NUMBER: 02-008-14
GROUP: Front Suspension
DATE: November 14, 2014

Front End Clunk Noise When Coming To A Stop - Mexico Only

Fig. 1 Tension Strut Replacement

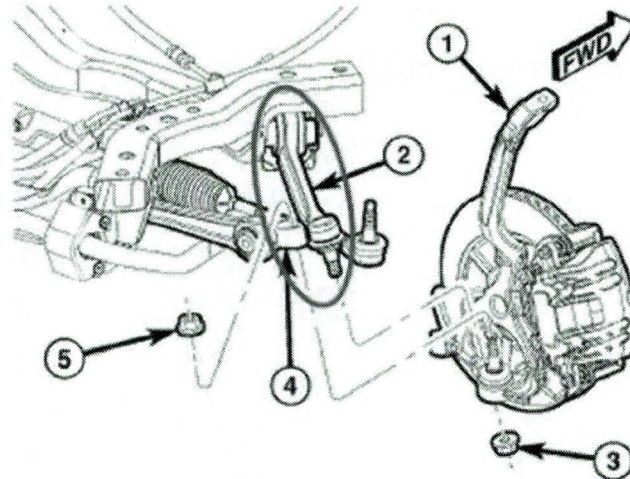
1. Replace both the left and right side tension struts. Refer to the detailed procedures available in DealerConnect>TechCONNECT> under: Service Info> 02 - Front Suspension> Front> STRUT, Tension, RWD> Removal/Installation.
